Modifications to Accor Sofitel Hotel Site 4A, Olympic Boulevard Sydney Olympic Park

SECTION 75W APPLICATION

Date: 17 January 2007

<u>A-2001</u>	<u>G</u>	<u>Changes to EA Approved Façade – North Elevation</u>	<u>21.12.06</u>
<u>A-2002</u>	<u>G</u>	<u>Changes to EA Approved Façade – South Elevation</u>	<u>21.12.06</u>
<u>A-2003</u>	<u>G</u>	<u>Changes to EA Approved Façade – East Elevation</u>	<u>21.12.06</u>
<u>A-2004</u>	<u>E</u>	<u>Changes to EA Approved Façade – West Elevation</u>	<u>21.12.06</u>

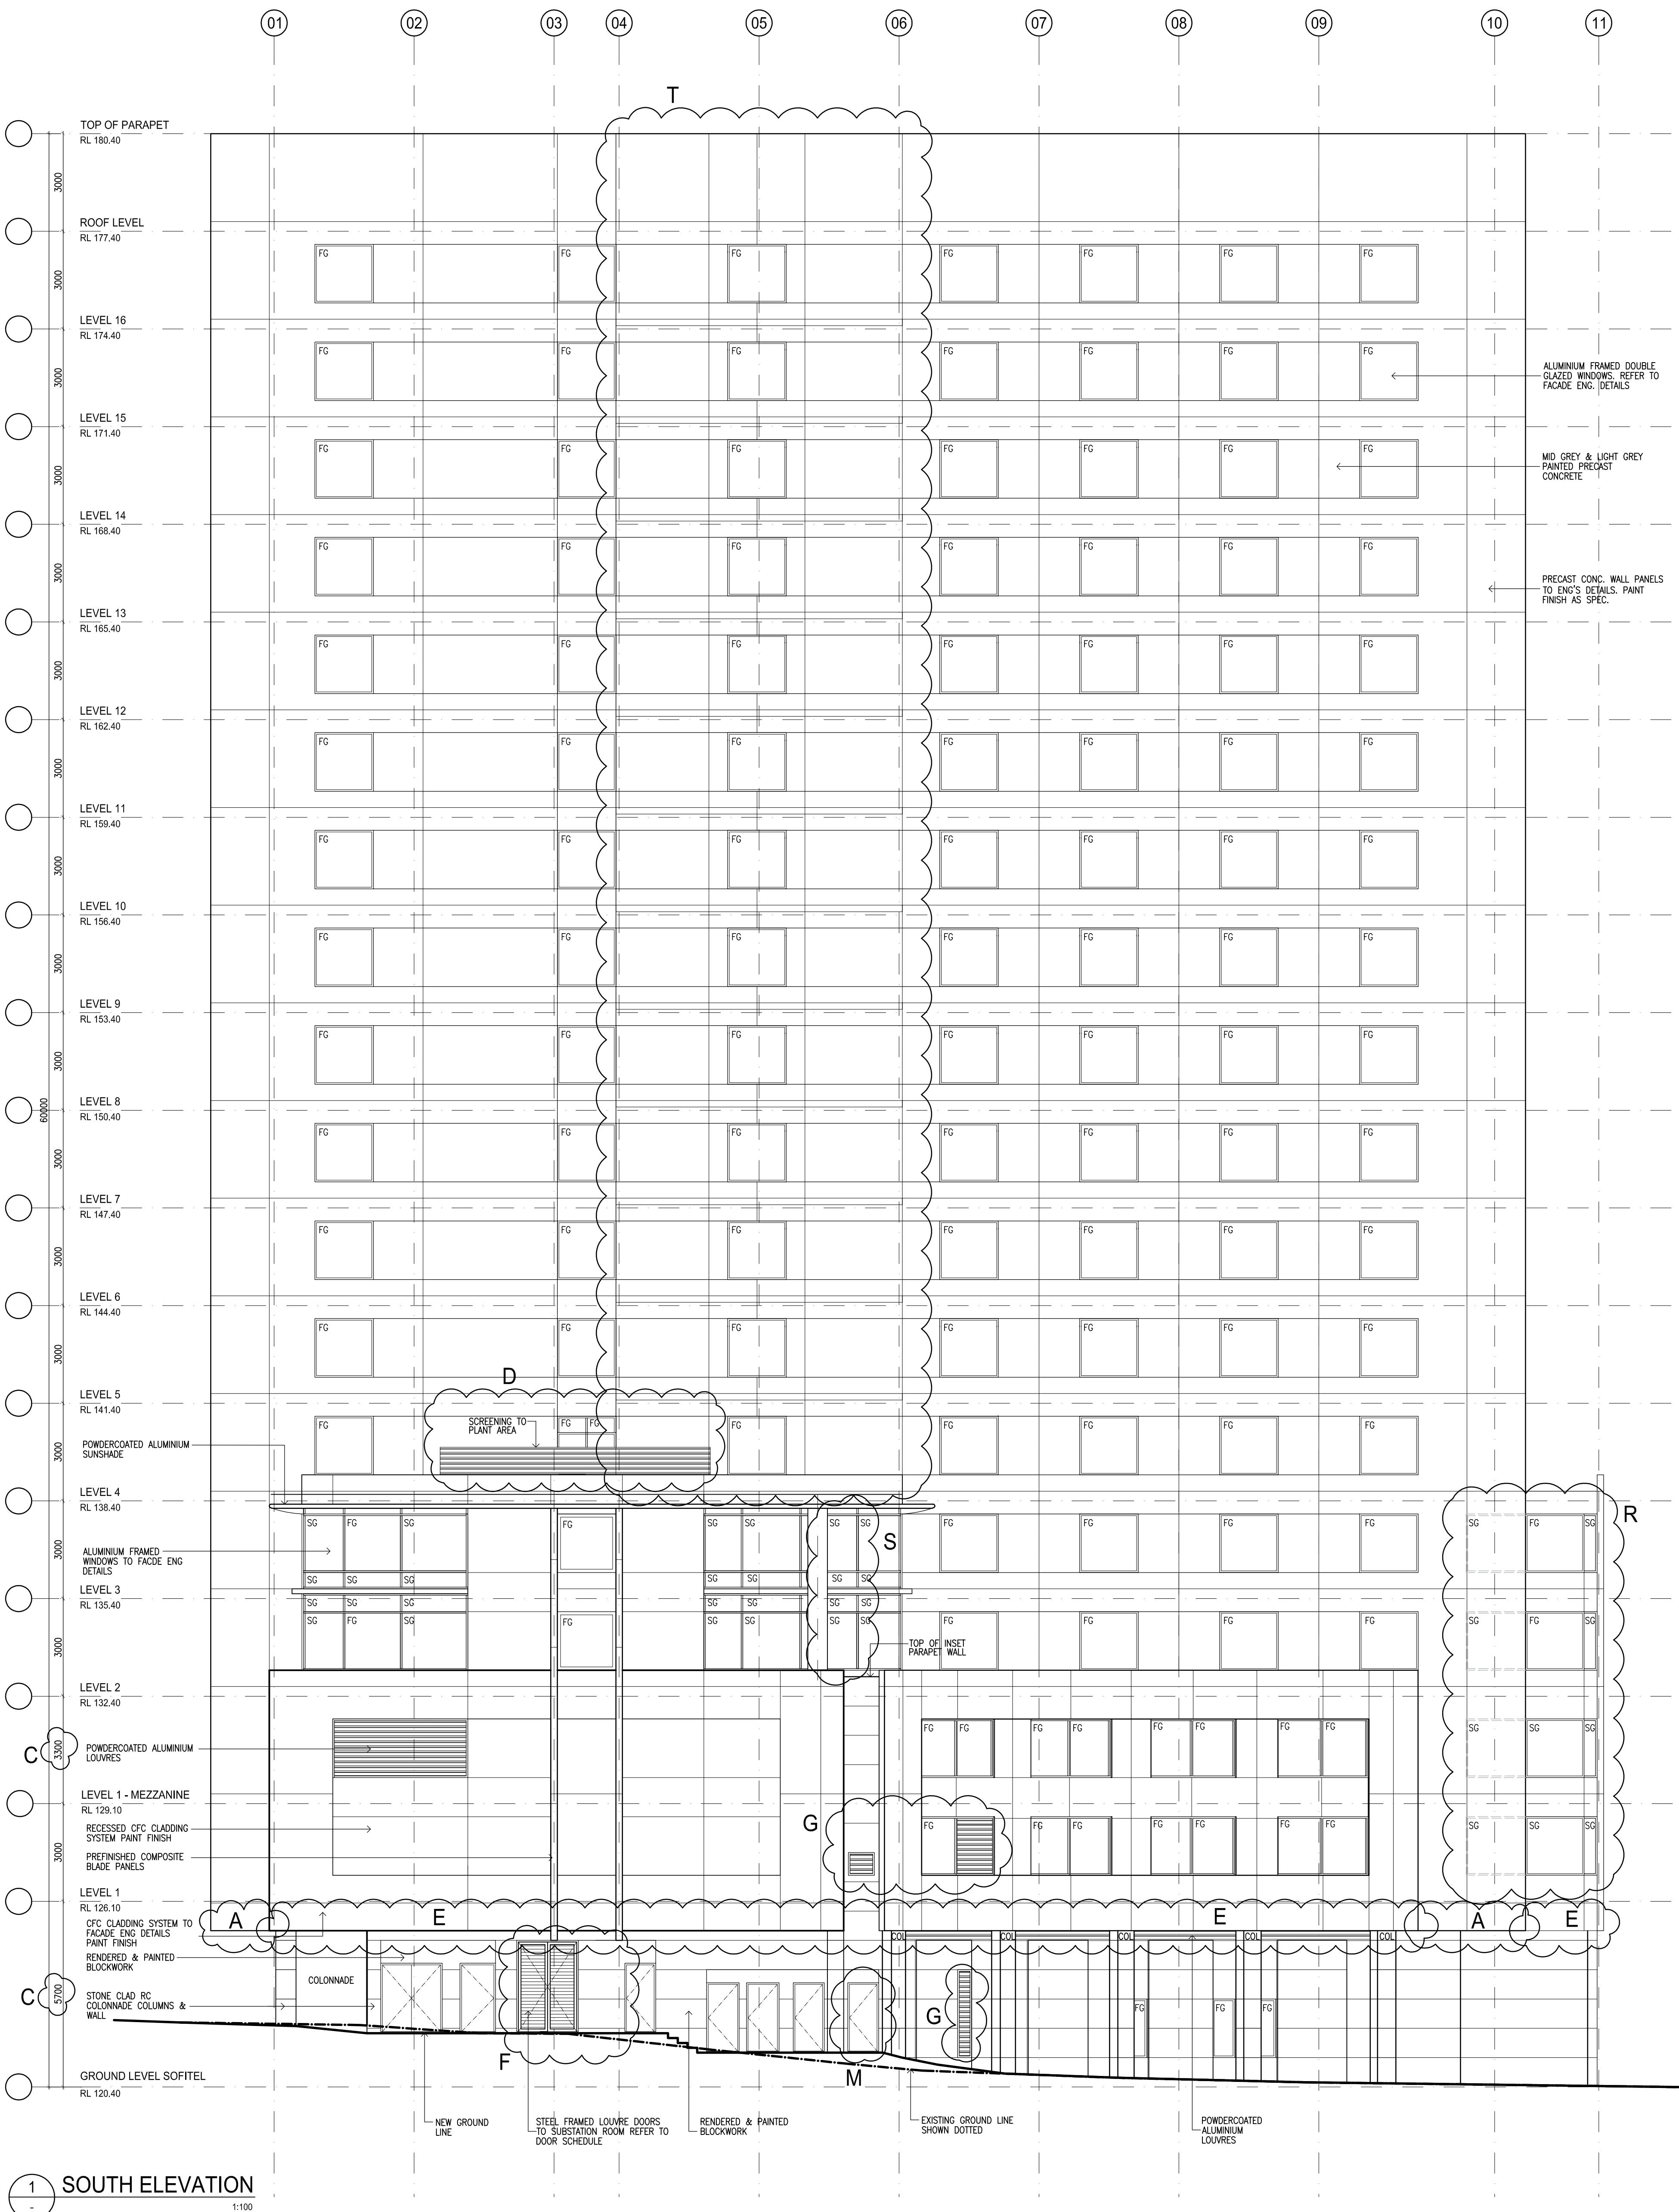
A: DENOTES DROP OF HEM OF PRECAST BY 300MM.
C: DENOTES CHANGE IN DIMENSION
D: DENOTES ADDITION OF PLANT ENCLOSURE

E: DENOTES DROP IN CLADDING BASE BY 300MM.
F: DENOTES INCREASED HEIGHT OF DOORS AND DELETION OF
FEATURE BLADES AT GROUND LEVEL
G: DENOTES INCLUSION OF LOUVRE
M: DENOTES FIRE CONTROL ROOM DOOR RELOCATED

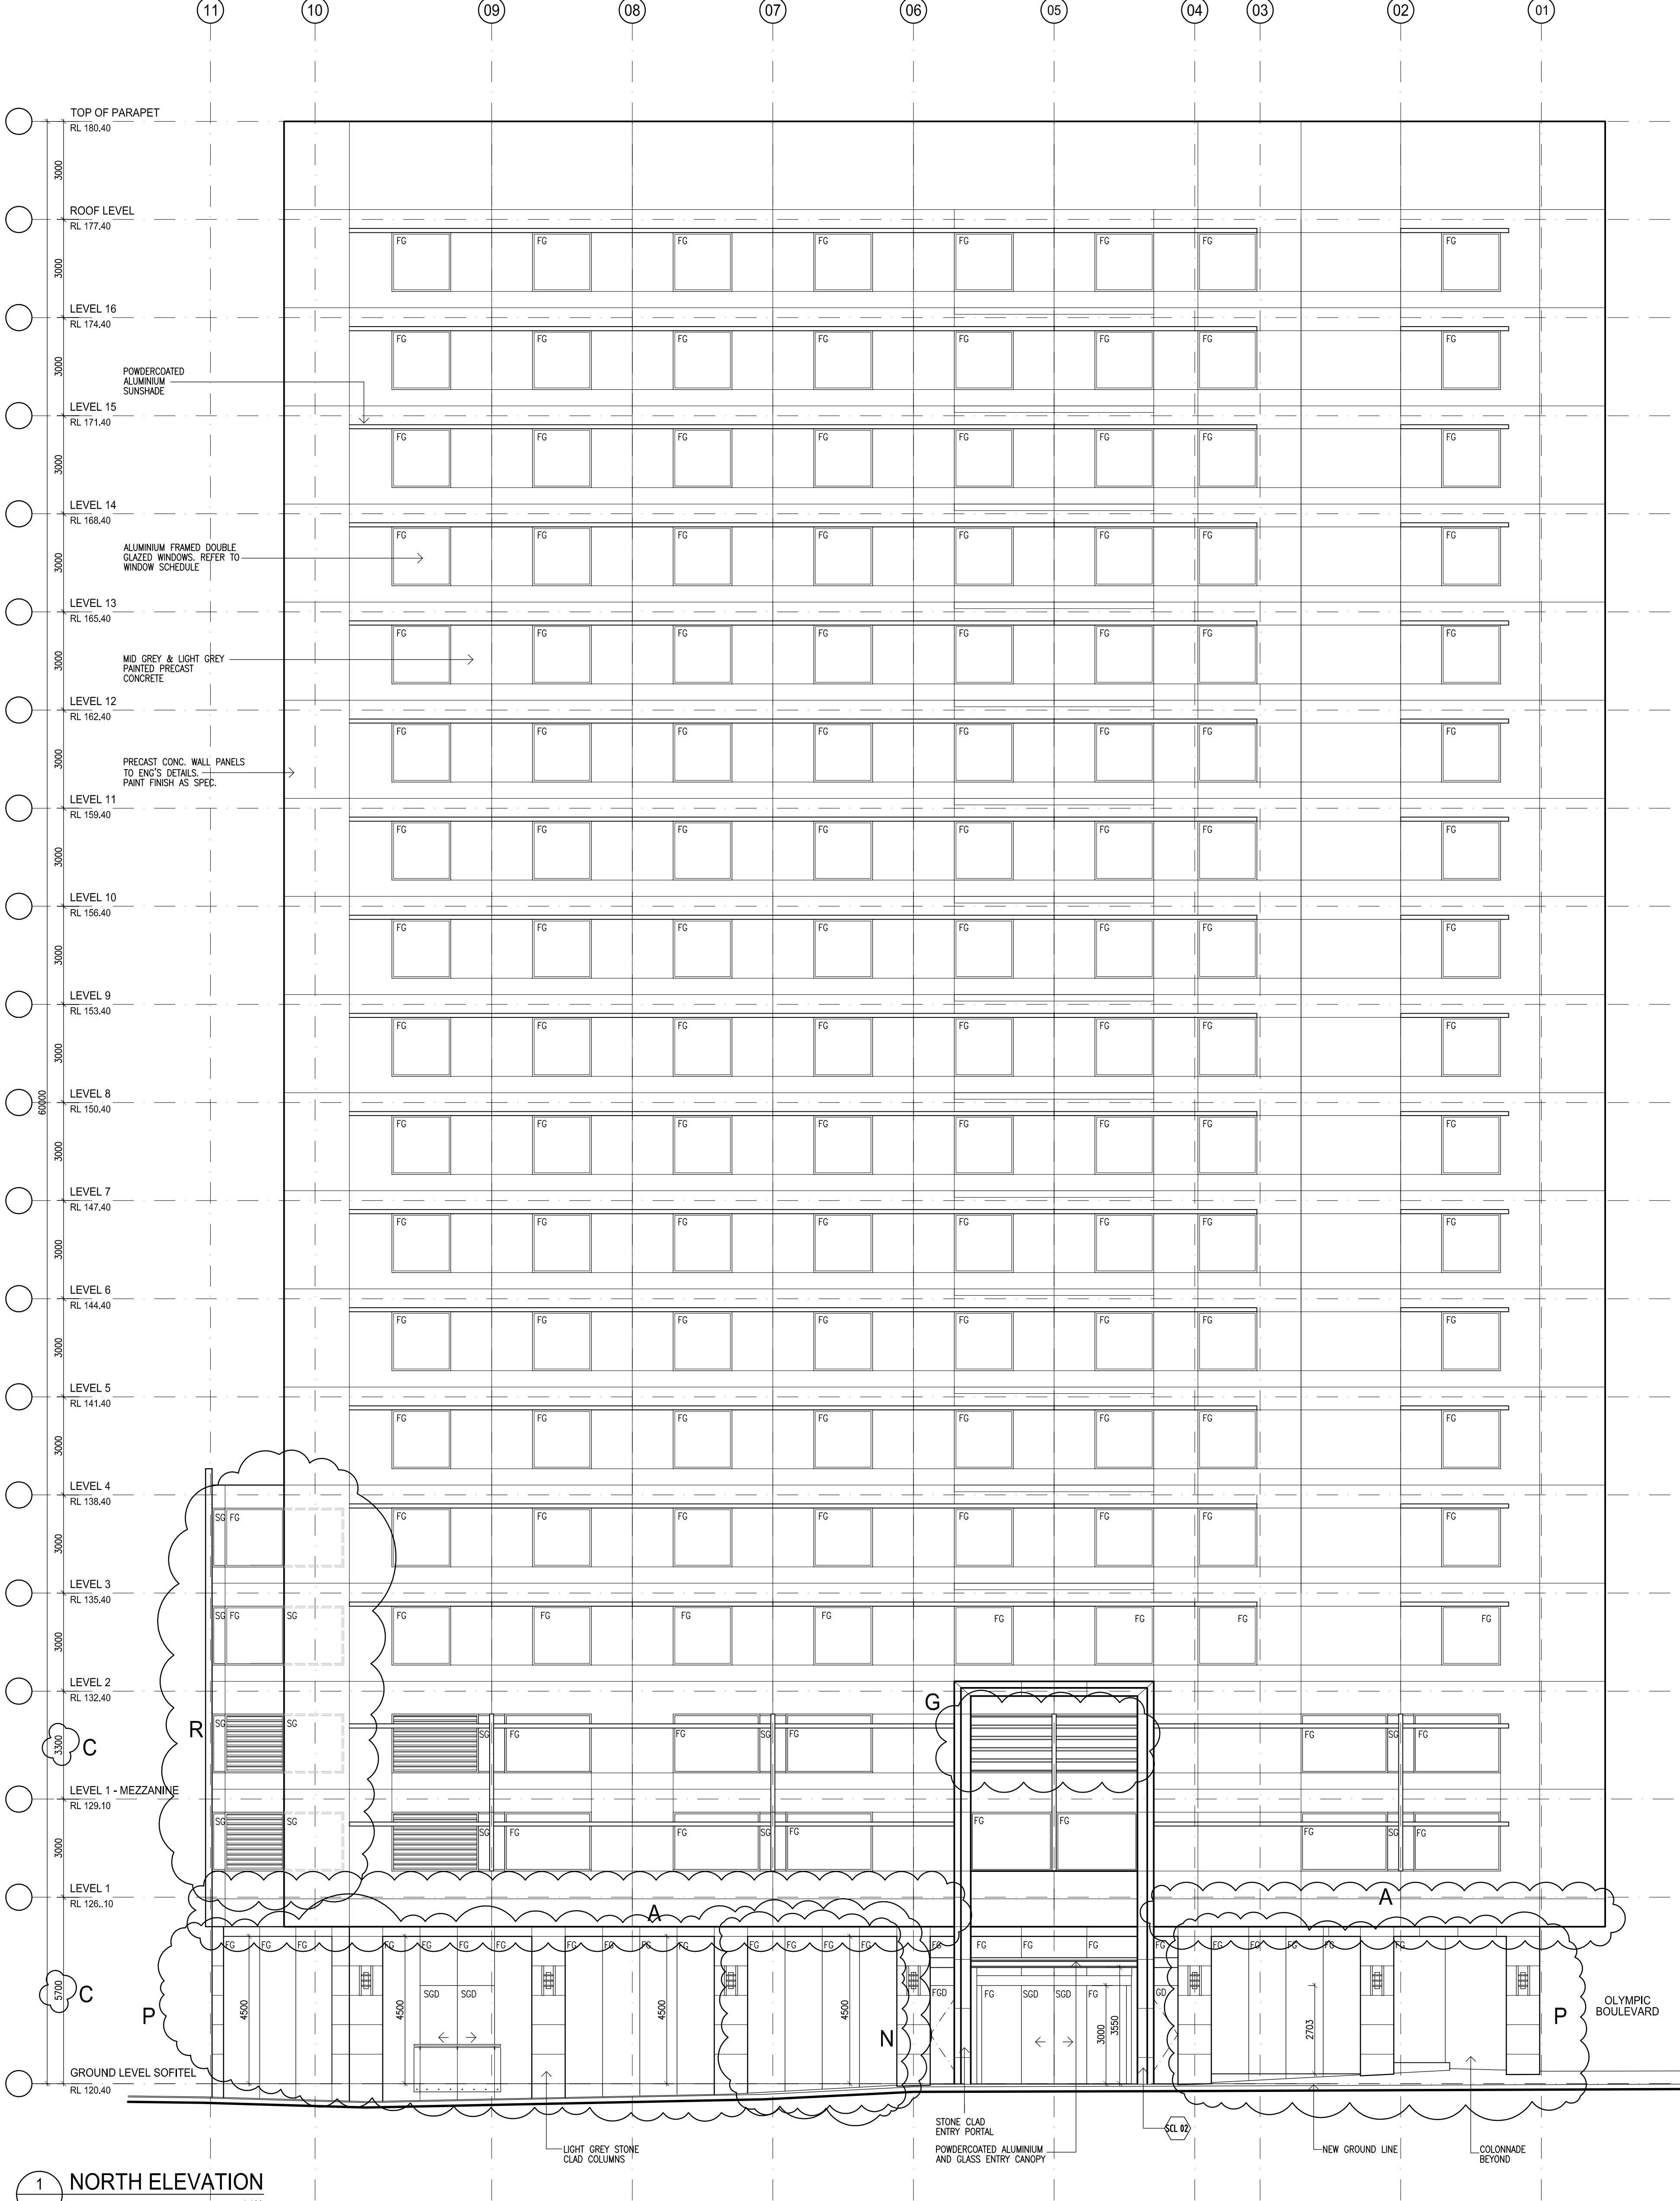
R: FENESTRATION ADJUSTED.
S: DENOTES SPANDREL GLASS IN LIEU OF FIXED GLAZING.
T: PANEL JOINTS / GROOVES ADJUSTED.

A: DENOTES DROP OF HEM OF PRECAST BY 300MM.
 B: DENOTES VOID CREATED IN FACADE BY LOBBY ATRIUM - N/A
 C: DENOTES CHANGE IN DIMENSION
 G: DENOTES INCLUSION OF LOUVRE
 N: DENOTES FACADE RECESS TO ACCOMMODATE TROLLEY BAY
 P: DENOTES DELETION OF FRAMED GLASS & TRANSOM IN LIEU OF FULL HEIGHT FRAMELESS GLASS.
 Q: AEROFOIL LOUVRES TO SMOKE EXHAUST SYSTEM IN LIEU OF GLAZING
 R: FENESTRATION ADJUSTED.
